SITE SUPPLEMENTAL INSTRUCTION

PROJECT: Forestside Estates
Attmar & Palleschi Drive
Brampton, ON

SITE SI NO. M-2

PURPOSE: To revise mechanical layout to suit architectural SI A-01 and City comments.

4TH FLOOR TYPICAL SUITE LAYOUT
TYPE 2C1, 2C, 2D2a & 2D

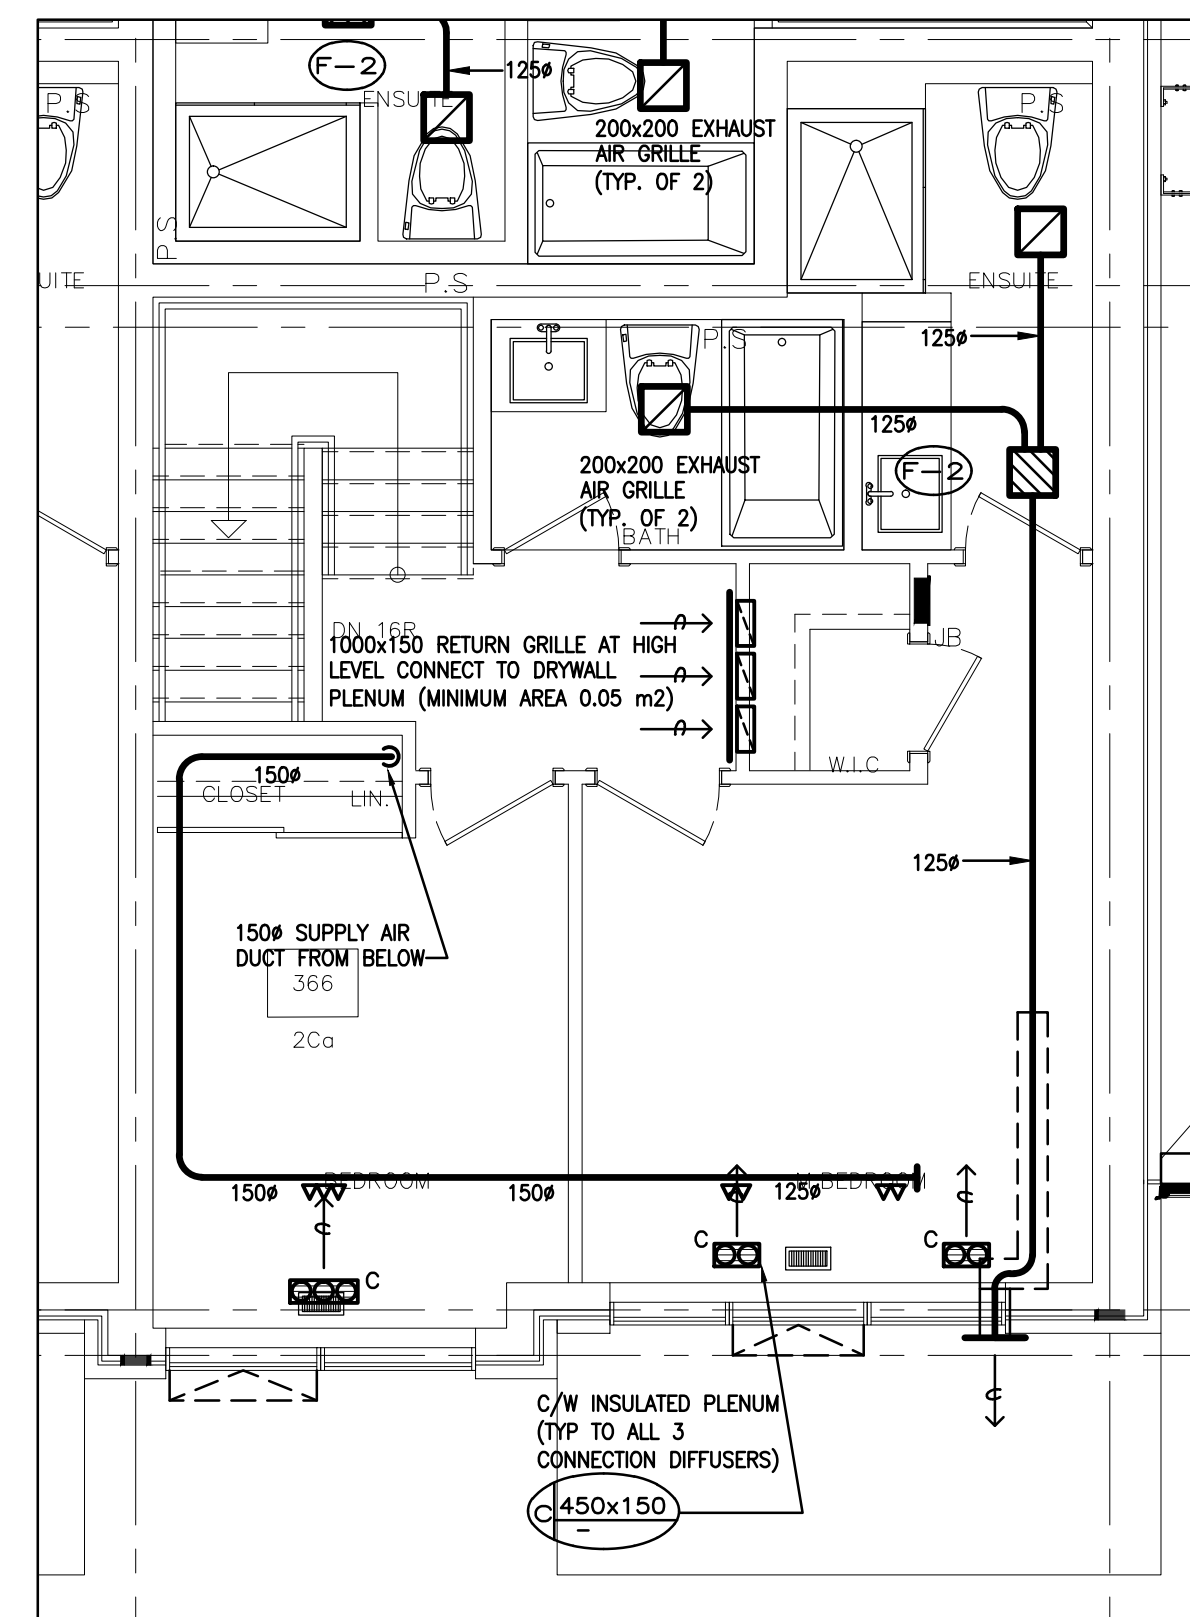
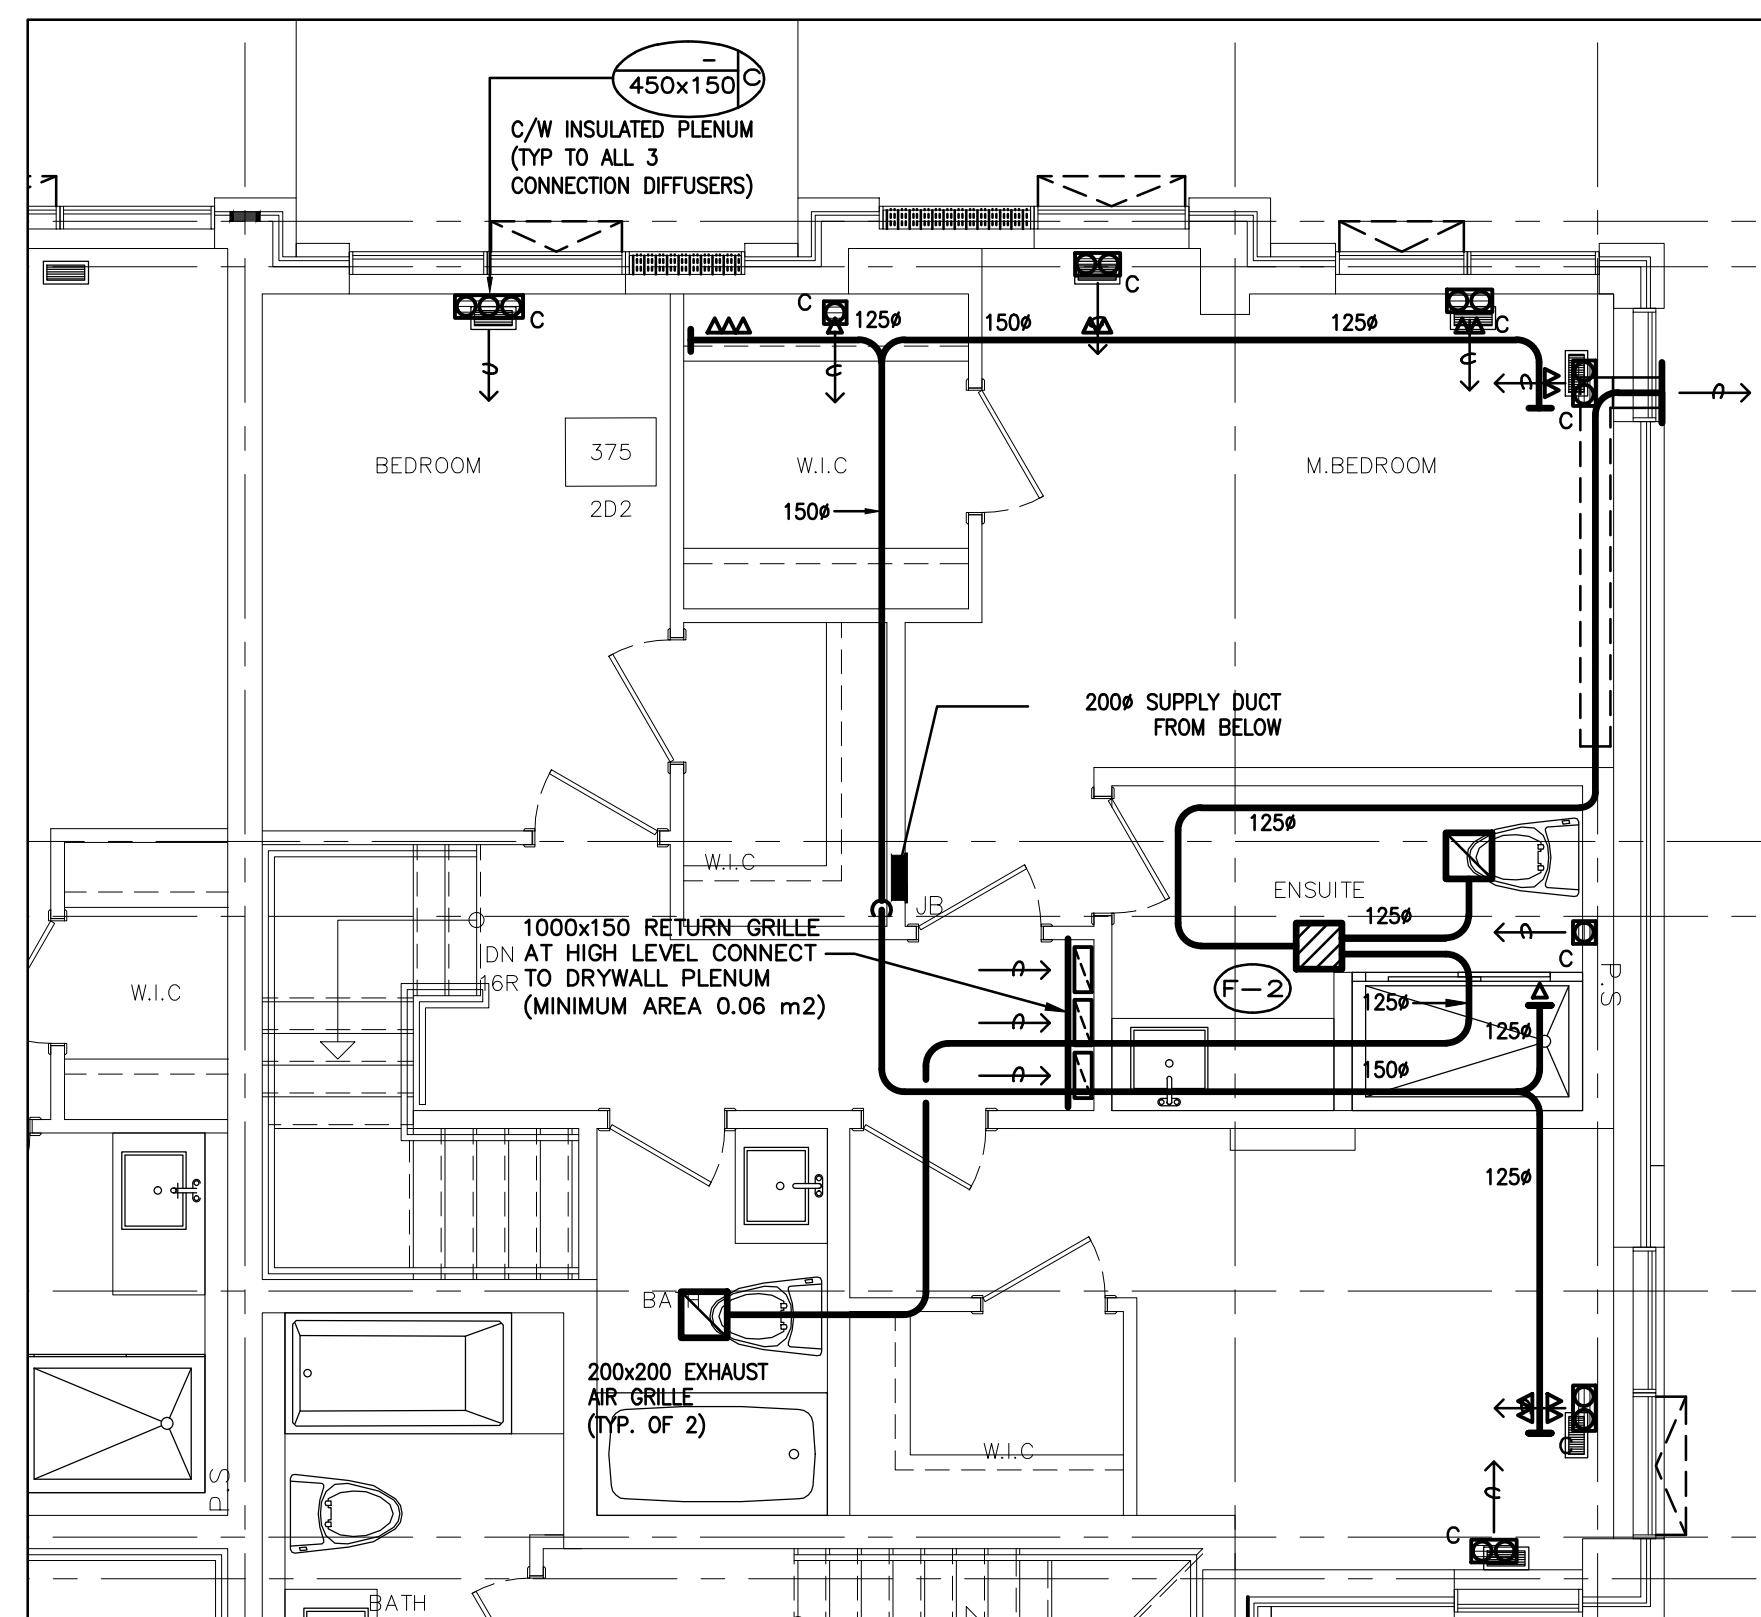
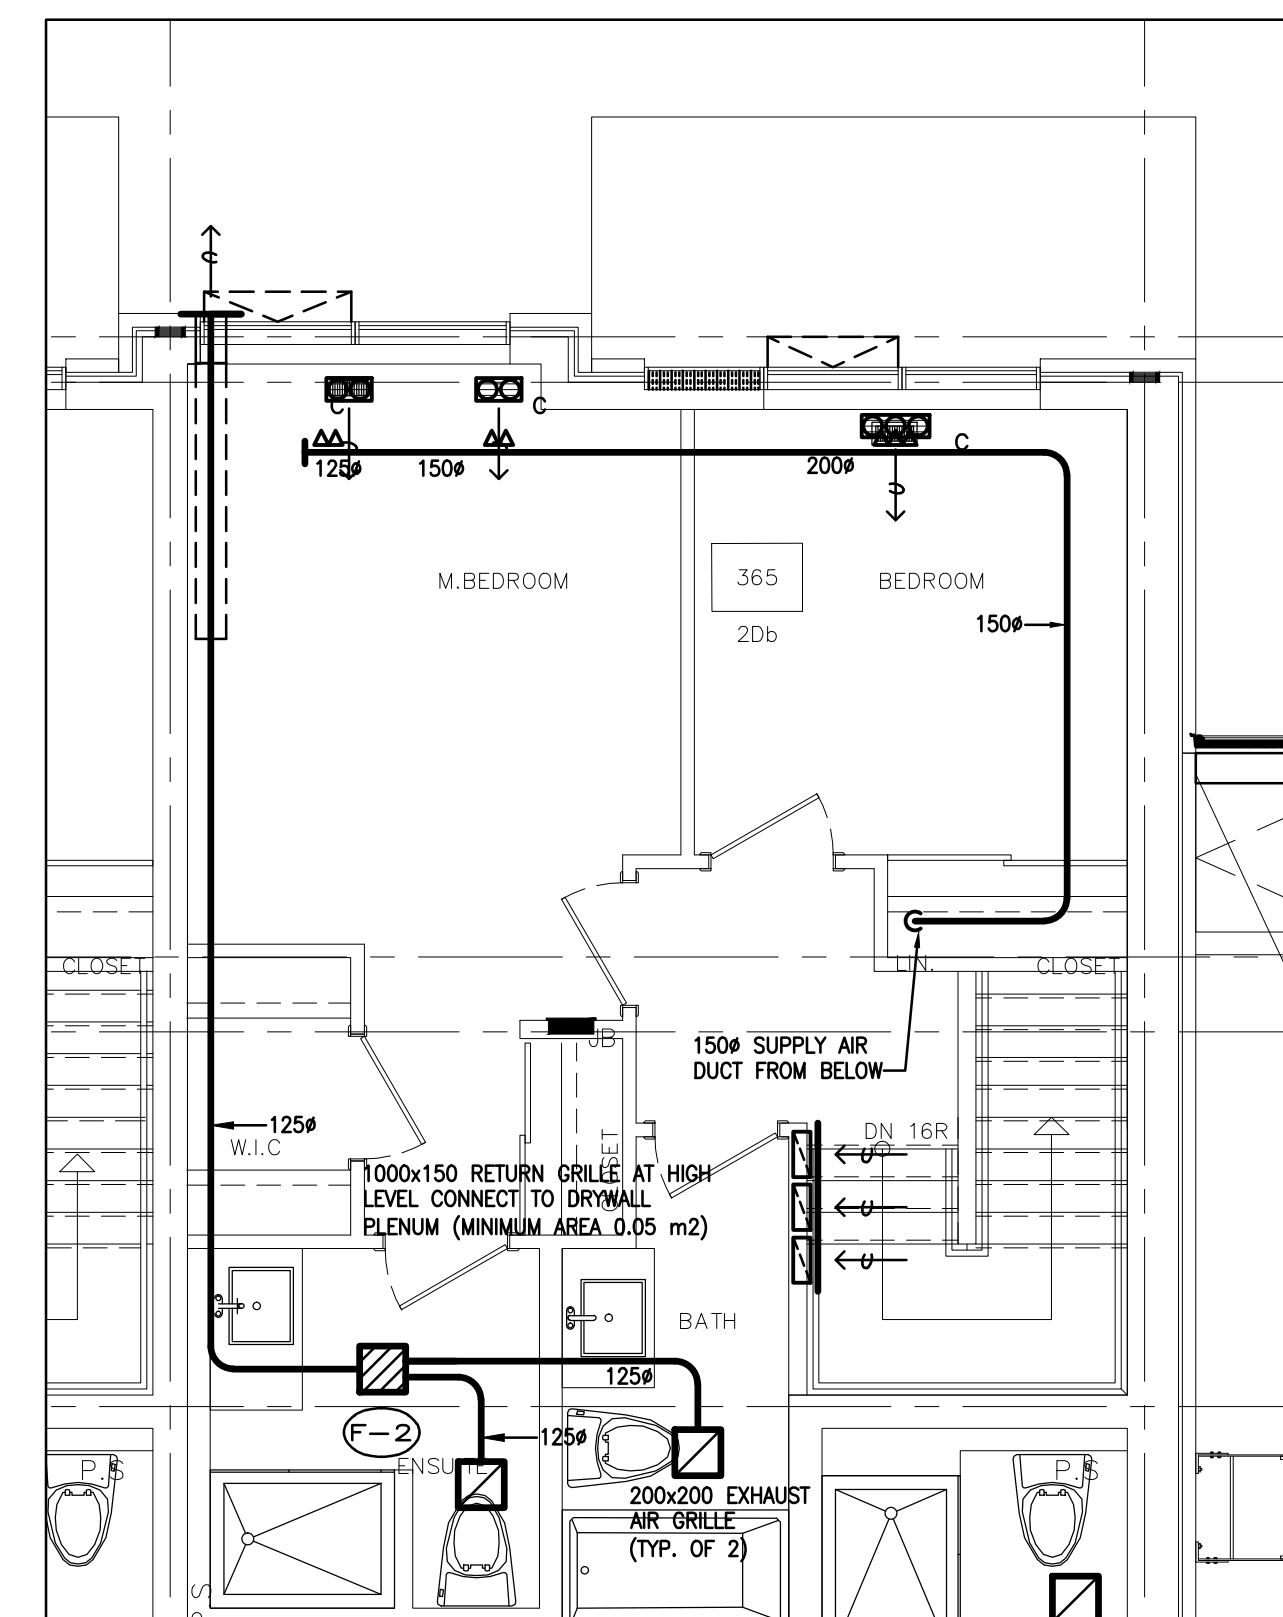
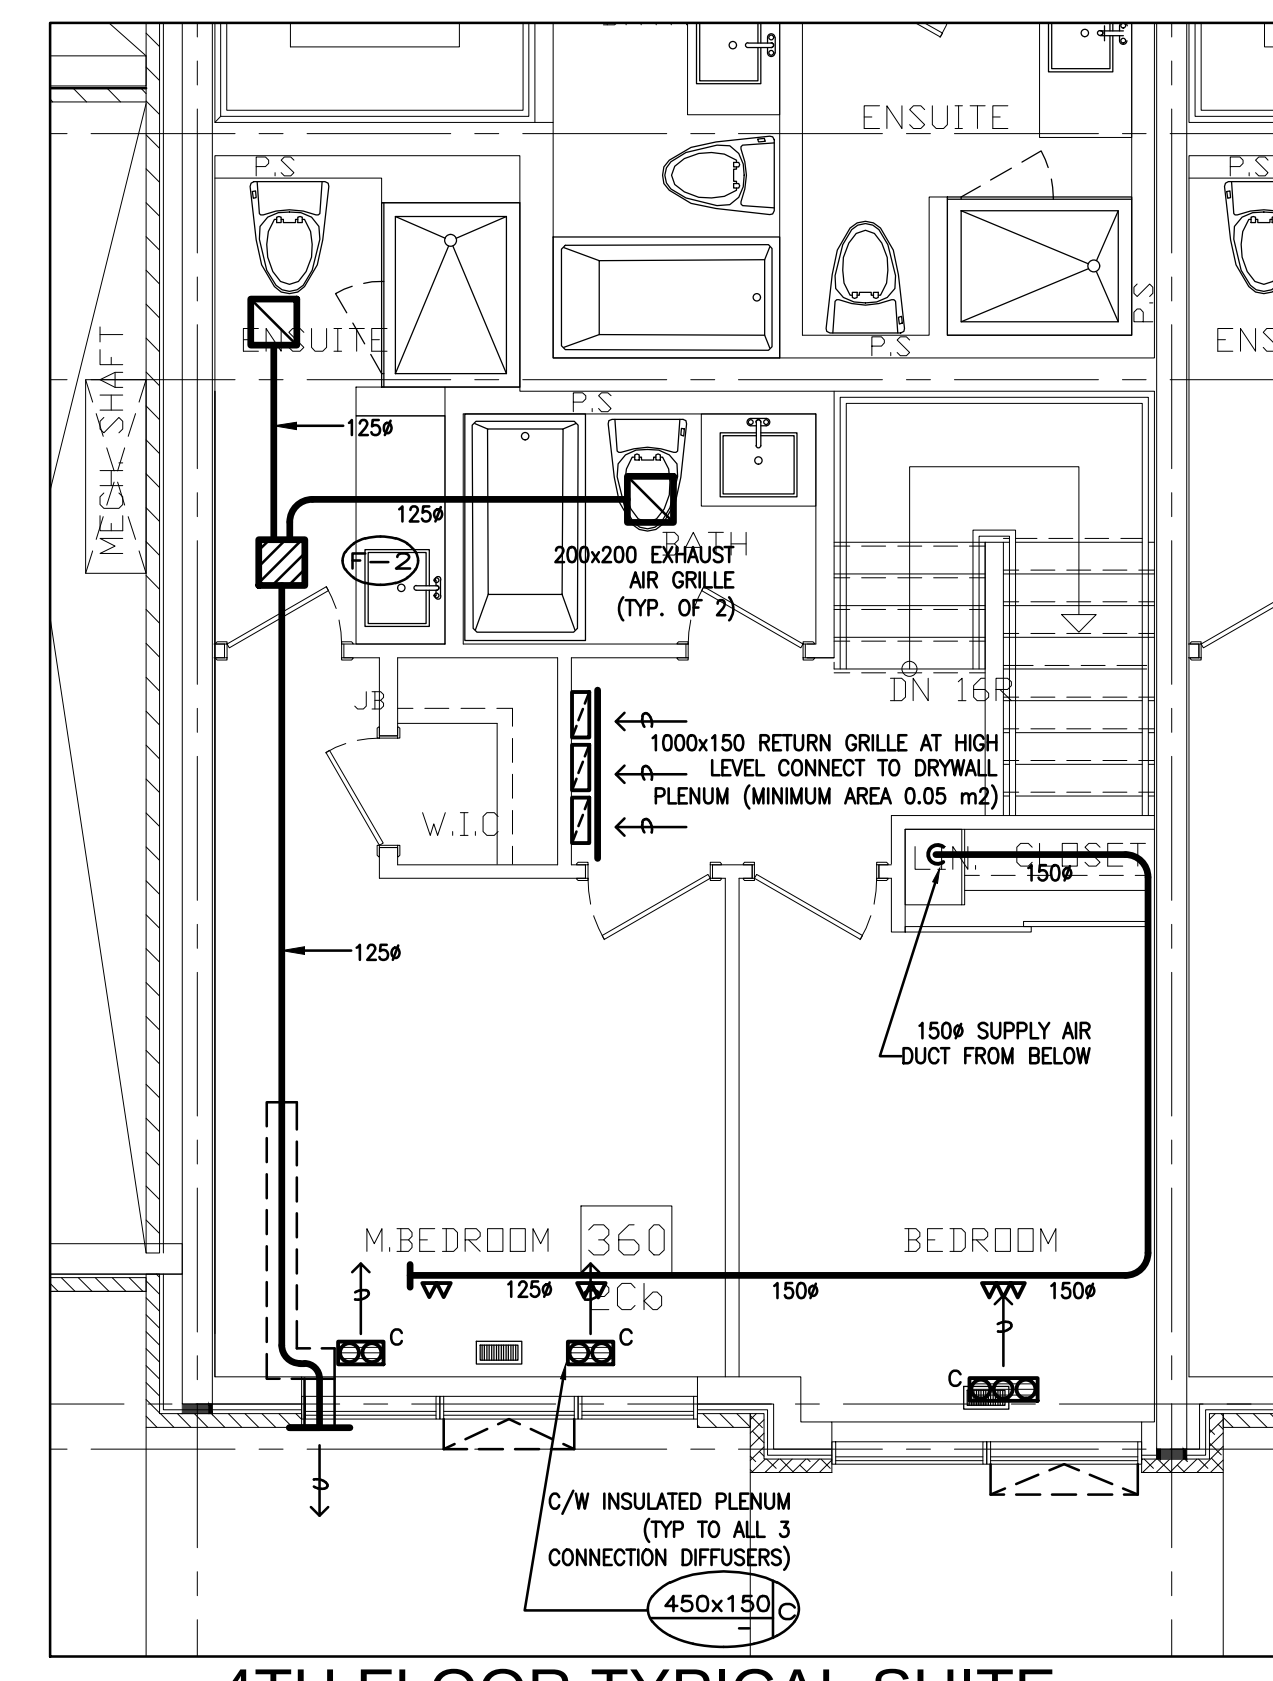
7.0 Reference Drawing M-45,M-46,M-47 (Typical Units - Mechanical) Issued

7.1 Added: Typical suite layout 2A1-R,2A-R and 2Aa-R.

7.2 Revised: Typical suite 2A,2A1,2Aa ,2Ab, 2A4,2A2,2A3,2A2a kitchen exhaust location according to code requirements.

DRAWN MC	CHECKED LM	SCALE N.T.S.
DATE MAY, 2019	PROJECT 18-017	DRAWING M-49
		OF

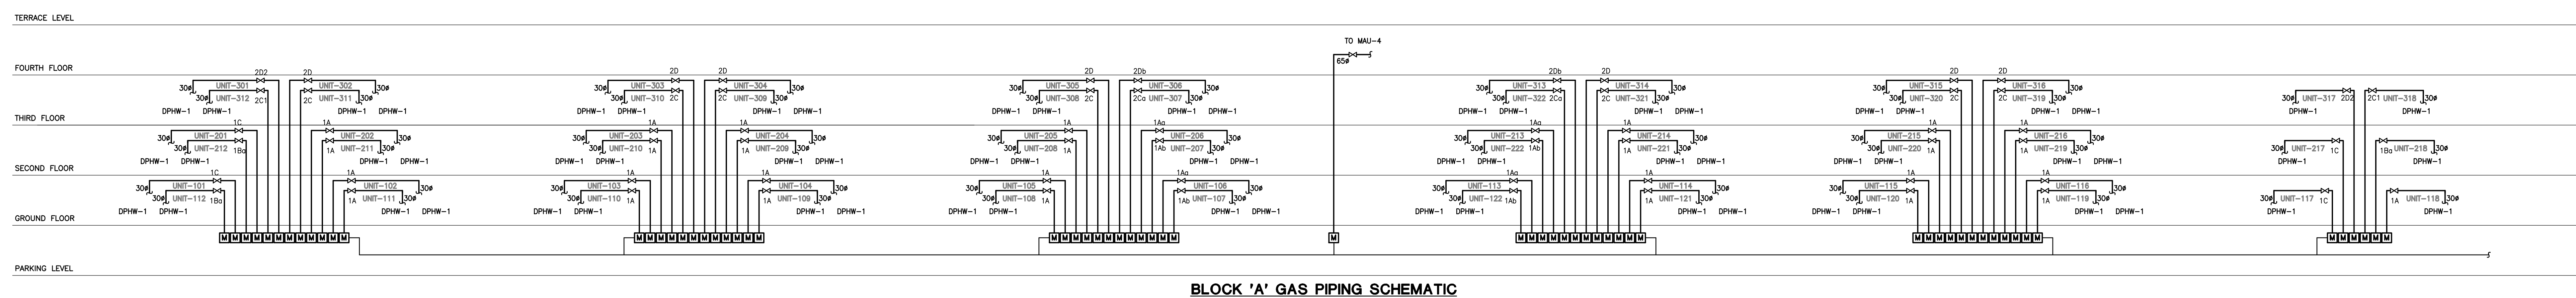
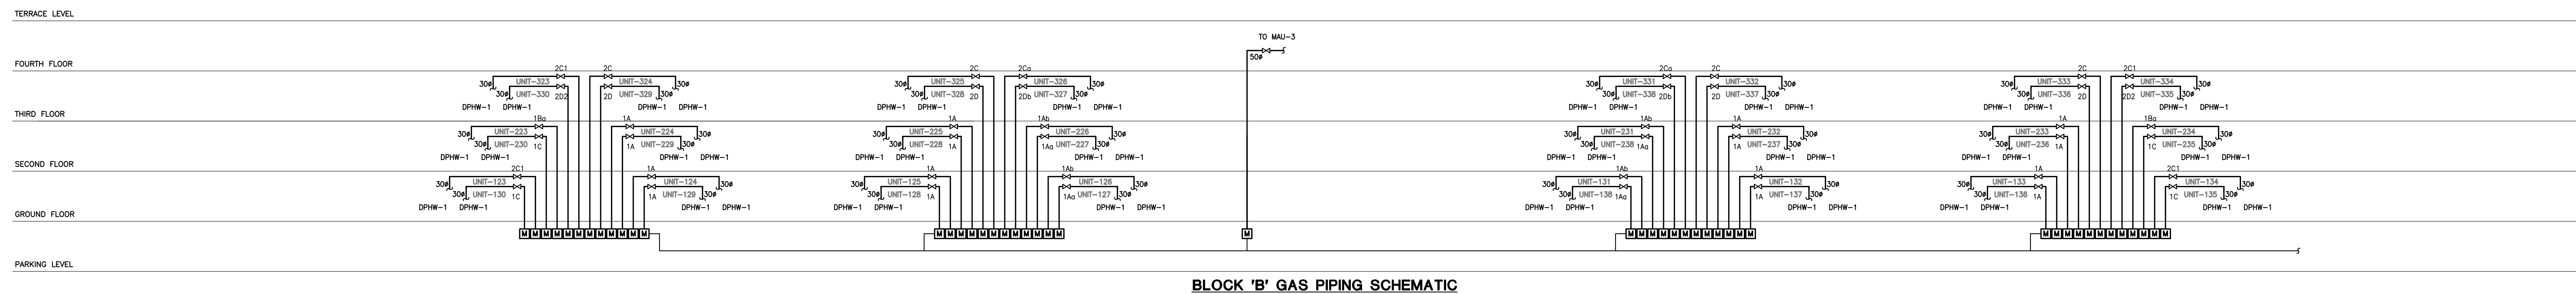
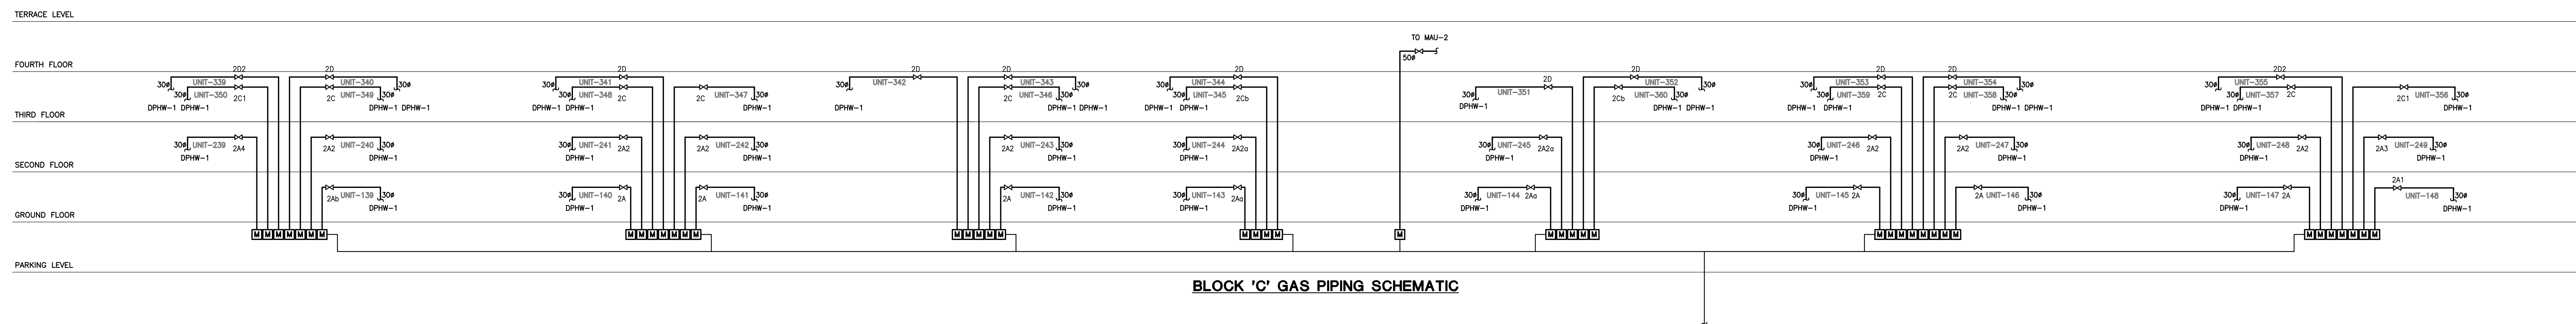
8.0 Reference Drawing M-49 (Gas Schematic - Mechanical) Issued

8.1 Revised: Building D gas schematic.
